PCN# 20250212004.1

**Qualification of RFAB using qualified Process Technology, Die Revision, Datasheet
and additional Assembly Site/BOM options for select devices
Change Notification / Sample Request**

Date: February 12, 2025

Sample product shipping label (not actual product label):

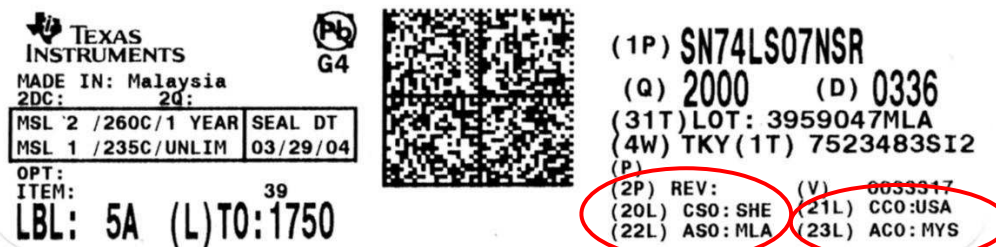
Changes to product identification resulting from this PCN:**Fab Site Information:**

Die Rev:**Current****New**

Die Rev [2P]	Die Rev [2P]
B, D	A
